RE: Bert Avenue Landfill
Cuyahoga County
Waste Stabilization Report
Notice of Deficiency

TO: Jerry Parker, DSIWM-NEDO
FROM: Doug Evans, DSIWM-CO
SUBJECT: Slope Stability Comments for Bert Avenue Site
DATE: May 18, 1998

Pursuant to your request, I have reviewed the slope stability analysis portion of the report titled, *Waste Stabilization Study Report*, dated March 27, 1998, and the report titled *Eastern Slope Stability Evaluation-Addendum*, dated April 13, 1998. Both reports were prepared by Dames & Moore and address stability issues with the proposed design of the waste containment cell at the Bert Avenue Site.

GCL Failure Envelope

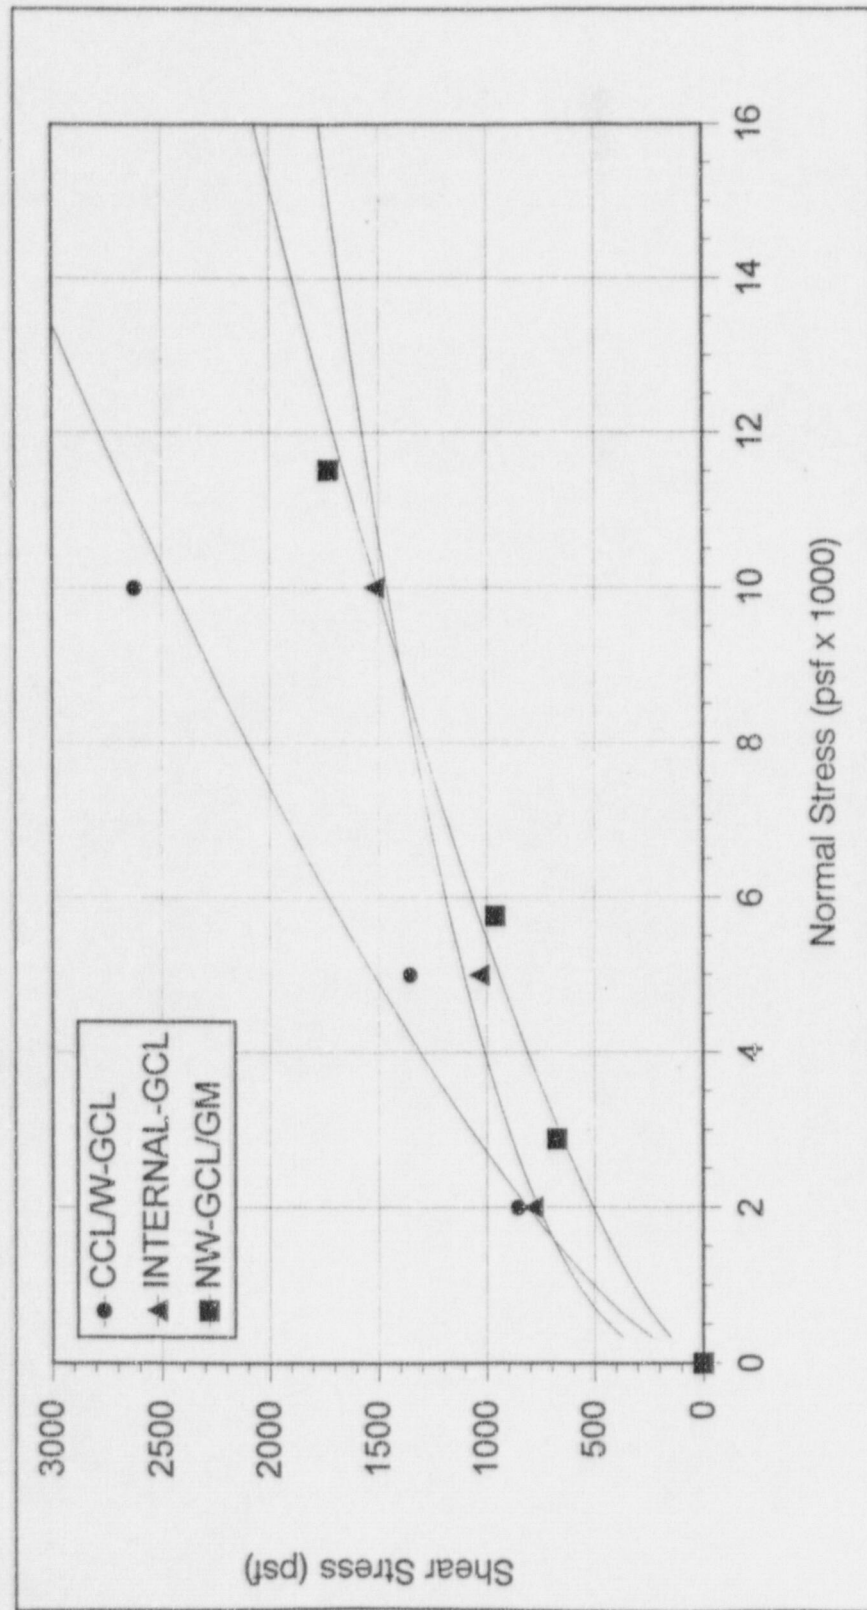
2. The incorporation of a GCL in the facility's design significantly heightens DSIWM's concerns over slope stability. It is recommended to test the GCL in accordance with the attached GCL advisory to alleviate these concerns. By following the advisory it is possible to reduce the FOS for failure surfaces passing through or along the GCL to 1.3 and 1.1 for static and dynamic conditions, respectively. Should the advisory not be followed, the appropriate FOS for failure surfaces involving the GCL are 2.0 and 1.7 for static and dynamic conditions, respectively, using a shear strength parameter equivalent to hydrated bentonite.

BERT AVE. Rotational Yield Co
SPENCER'S METHOD, FOS for Specified Surface = 1.001

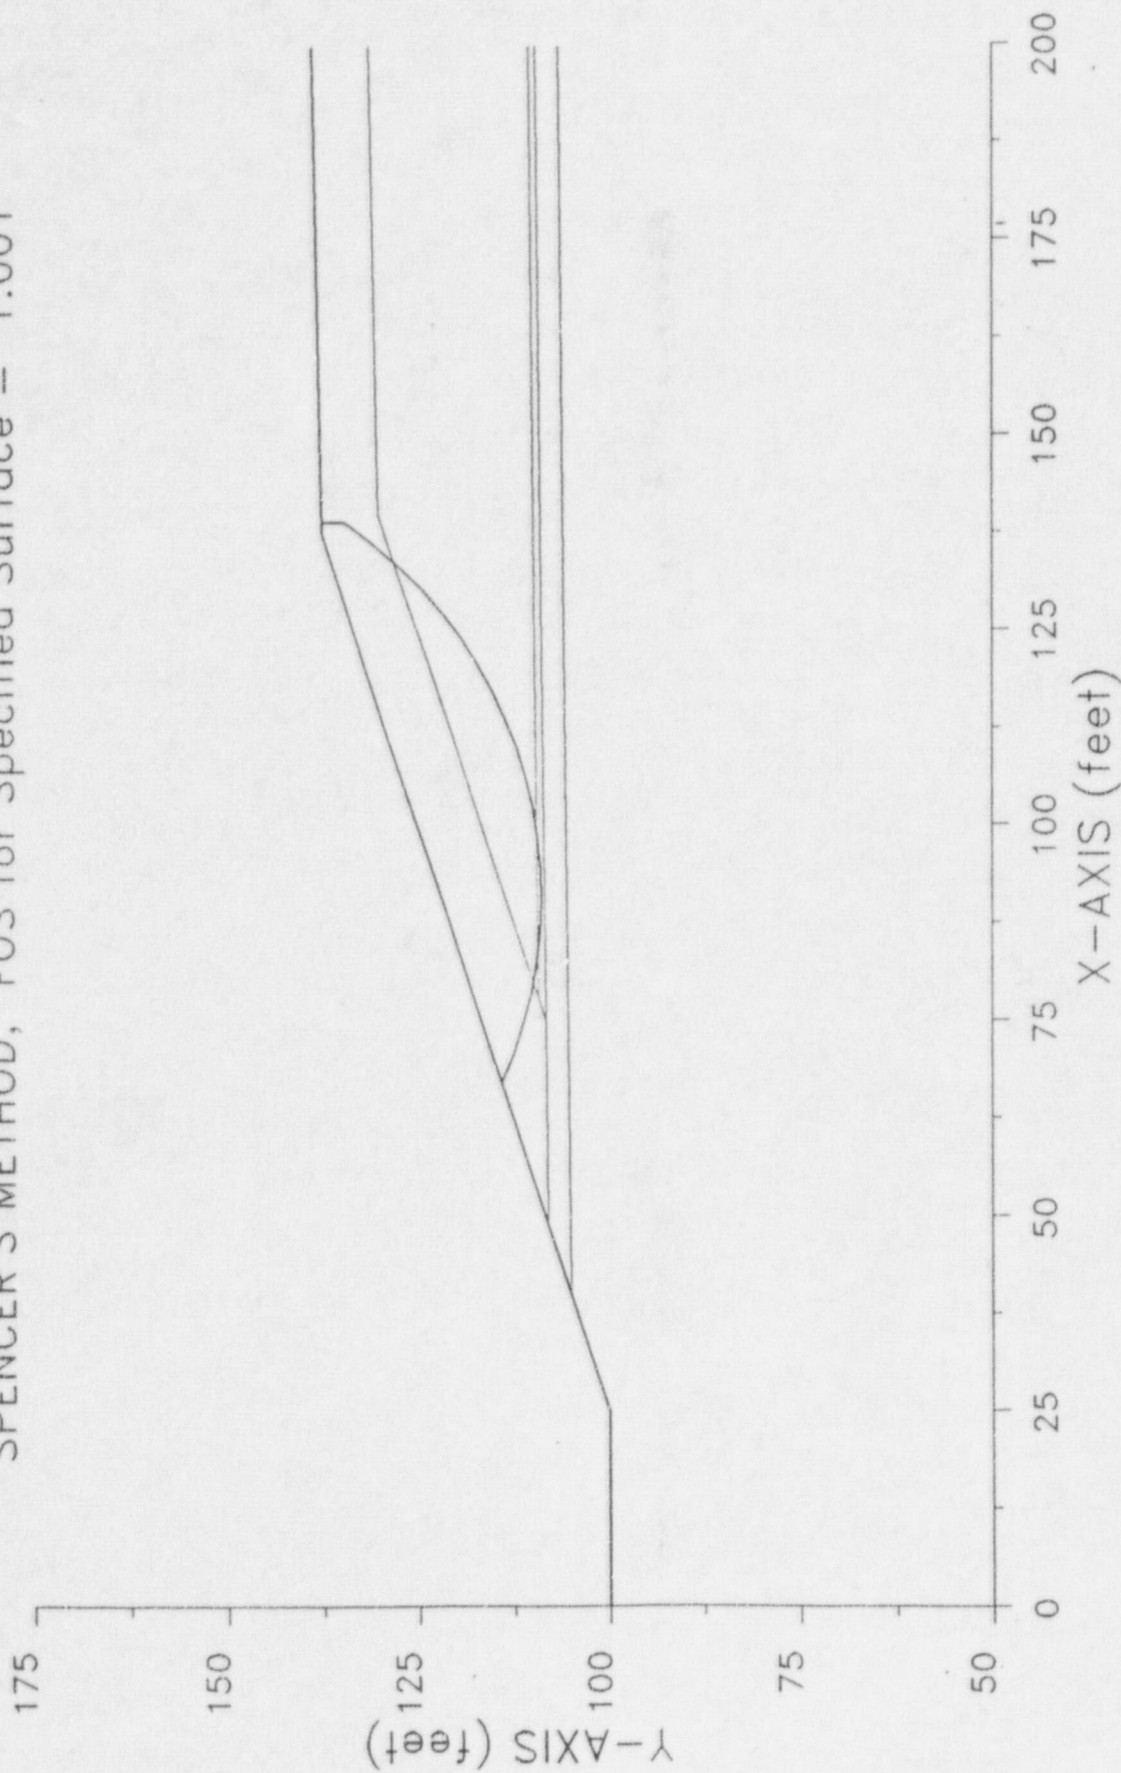
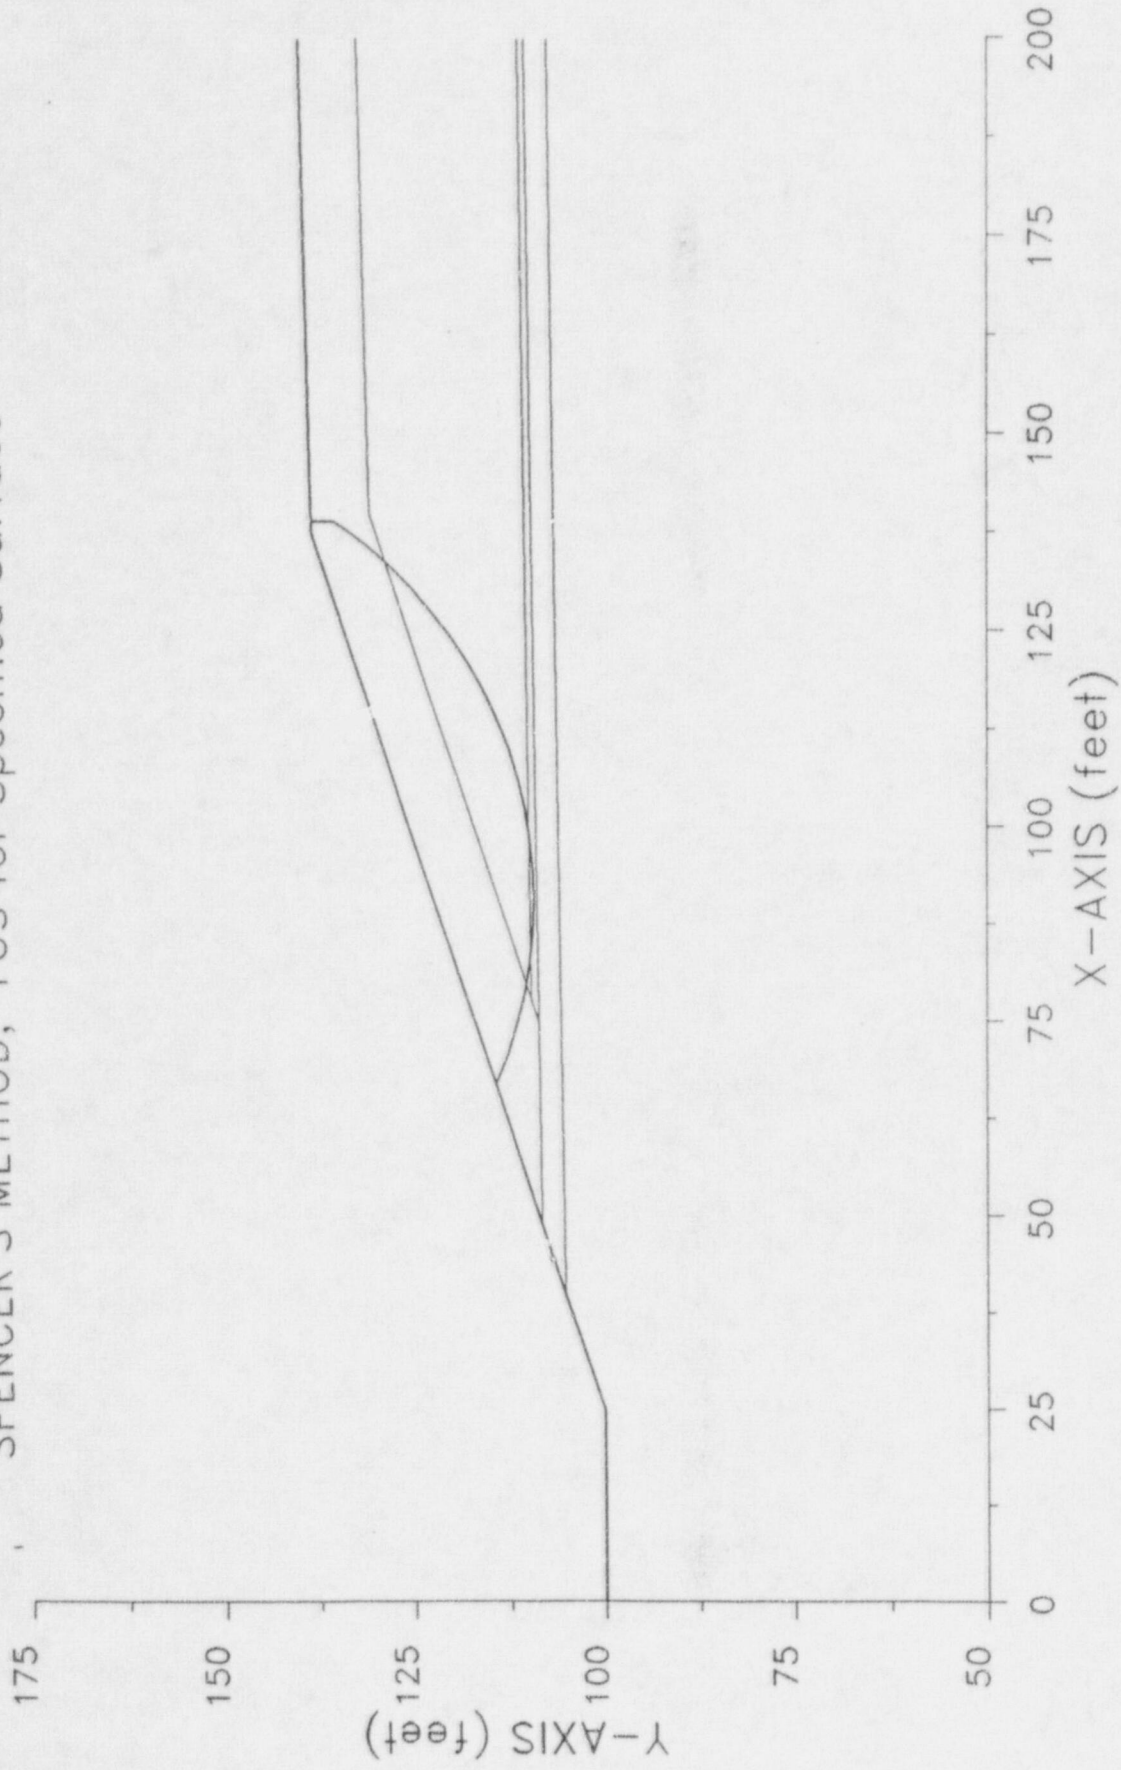
- A. It is not clear if deep-seated static and dynamic rotational failures within the waste have been analyzed. Information should be included in the proposal addressing this failure mode.
- B. The hand calculations for static and dynamic translational failures involving the GCL may not adequately model the complex stability issues. It is recommended to include the GCL into the computer analysis model.

The FOS (1.05) for deep-seated rotational failures through the waste is less than the regulatory minimum recommended value of 1.3. However, a simplified Newmark deformation analysis indicates that no deformation will occur due to the design earthquake.

Earthquake-Induced Deformations (6.5 M)

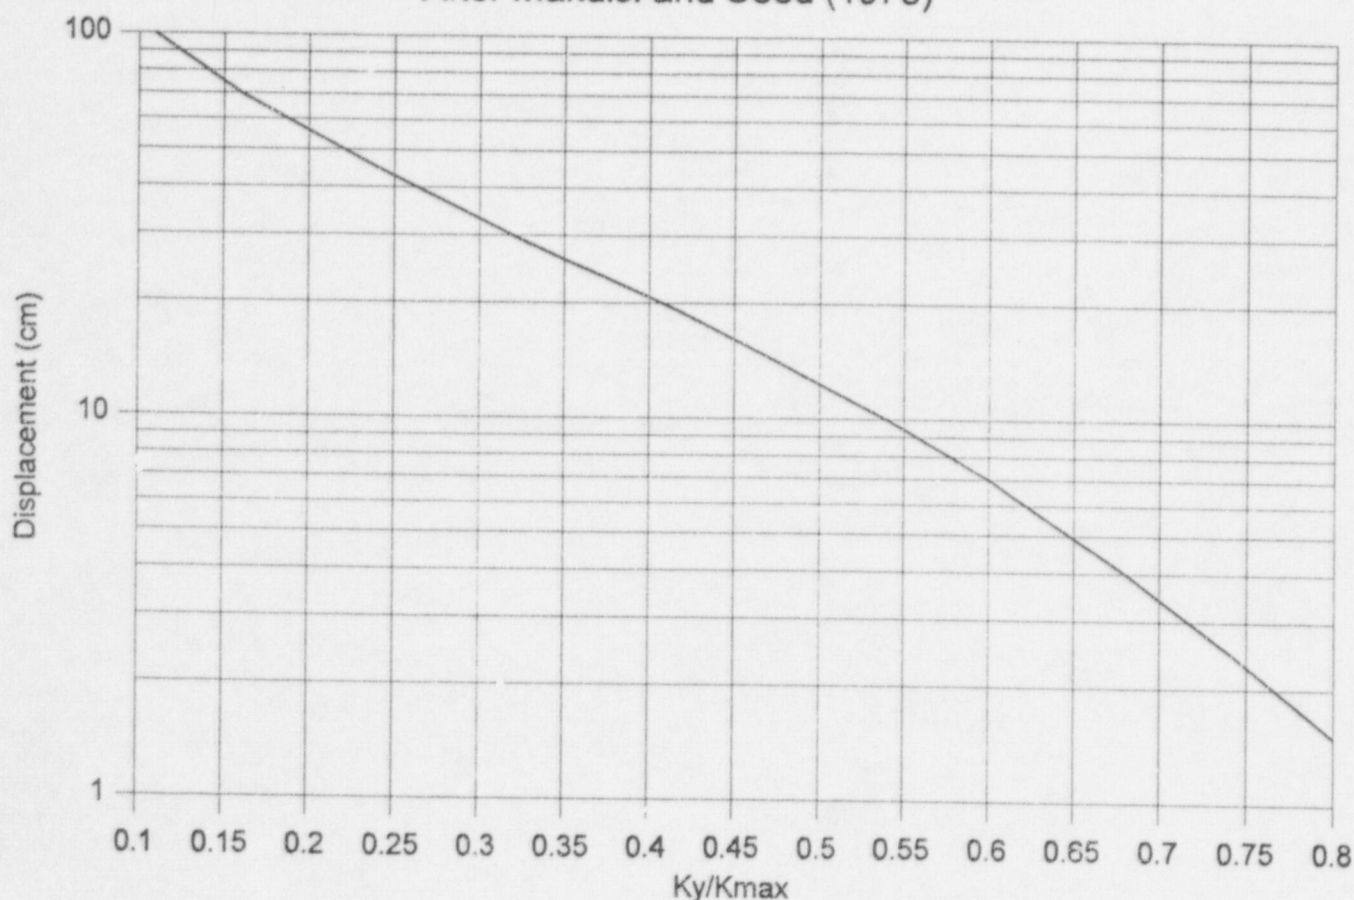
- The yield acceleration for this failure scenario is calculated to be 0.17g.
- The maximum seismic acceleration has been estimated to be 0.16g.

BERT AVE. Translational Yield Co.
SPENCER'S METHOD, FOS for Specified Surface = 1.003

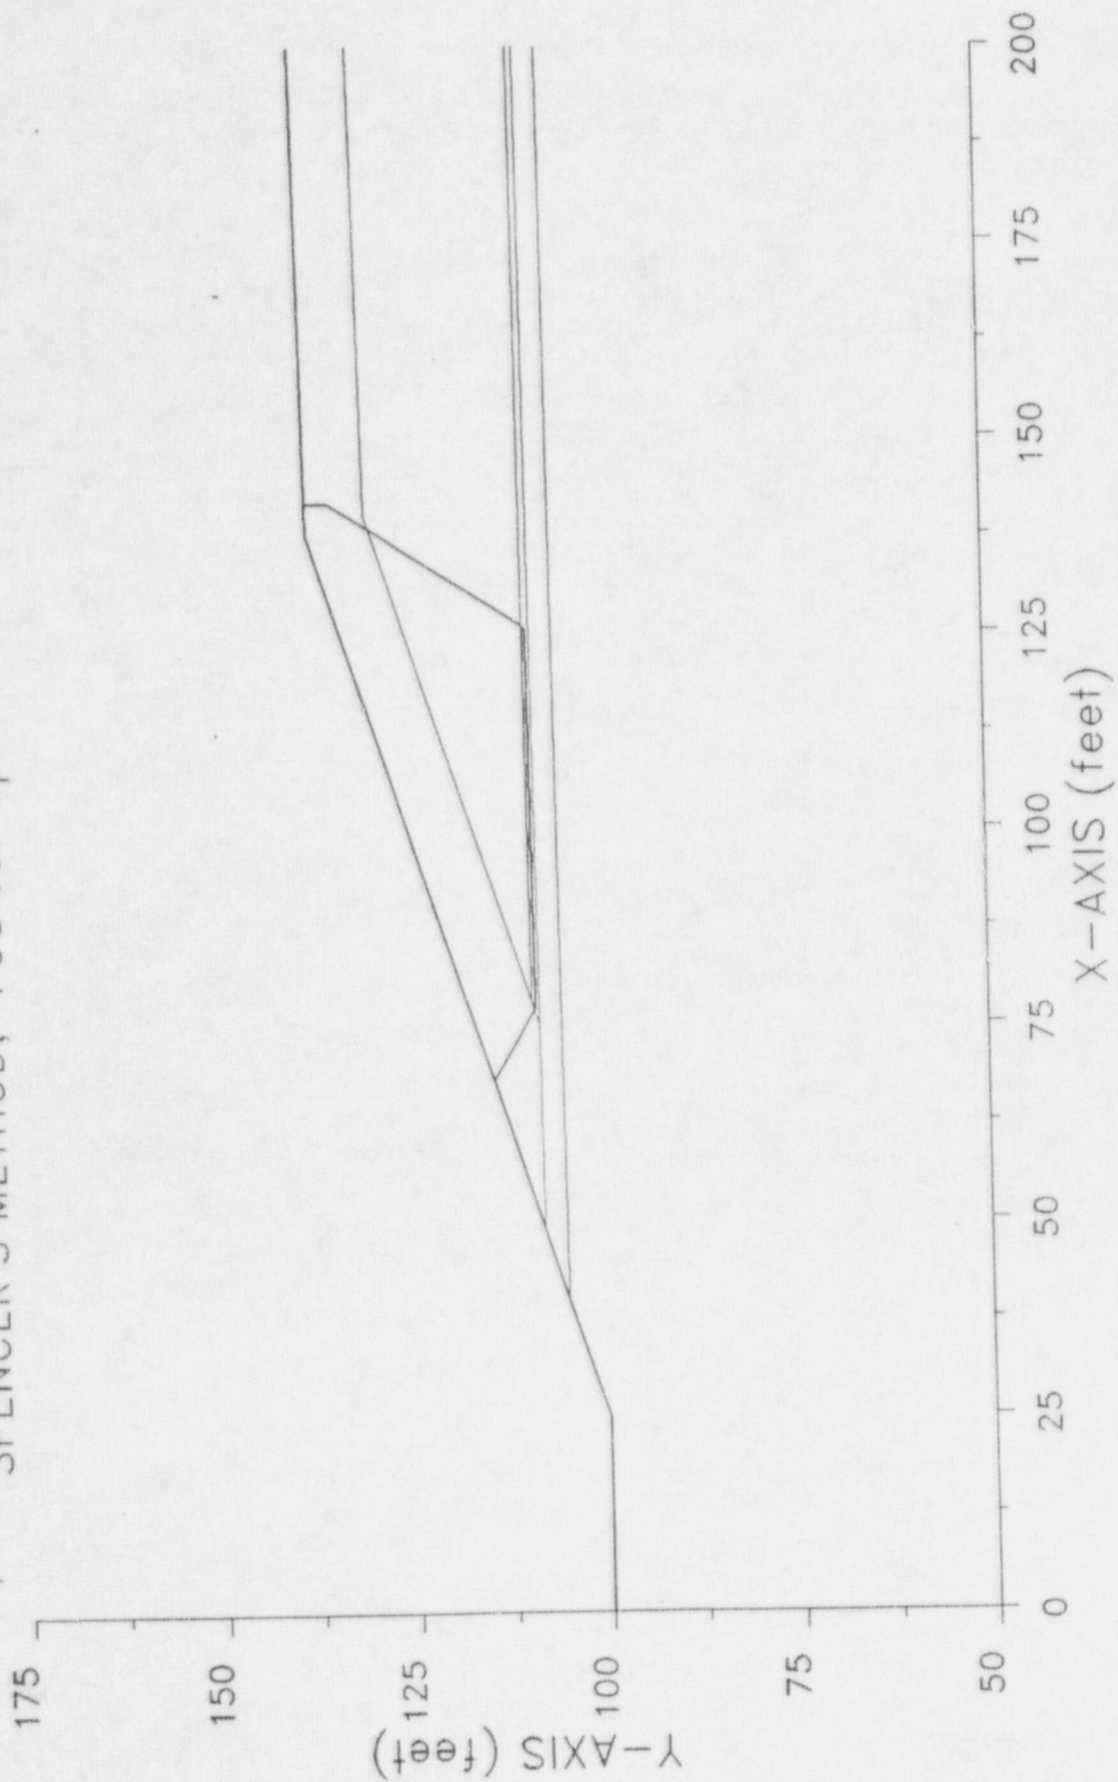
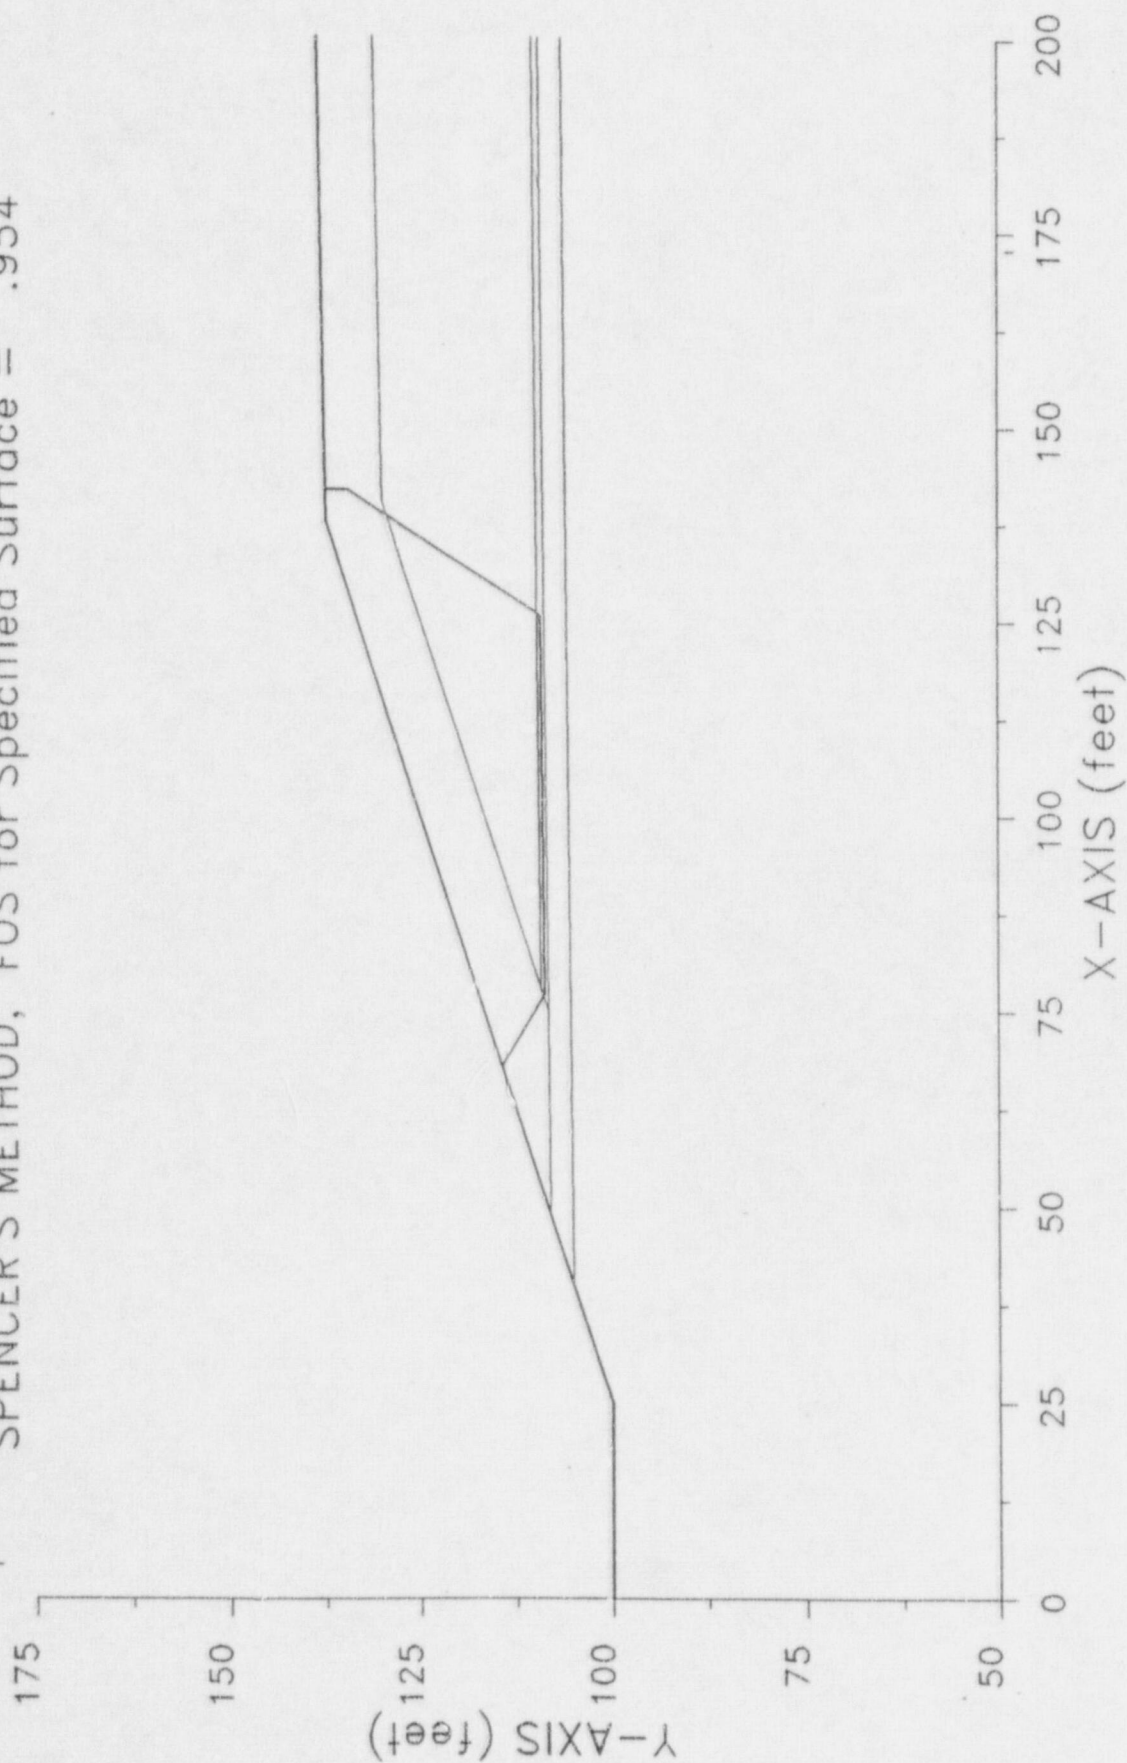
The FOS (0.95) for deep-seated translational failures involving the GCL is less than the regulatory minimum recommended value of 1.1. However, a simplified Newmark deformation analysis indicates that minimal deformation will occur due to the design earthquake.
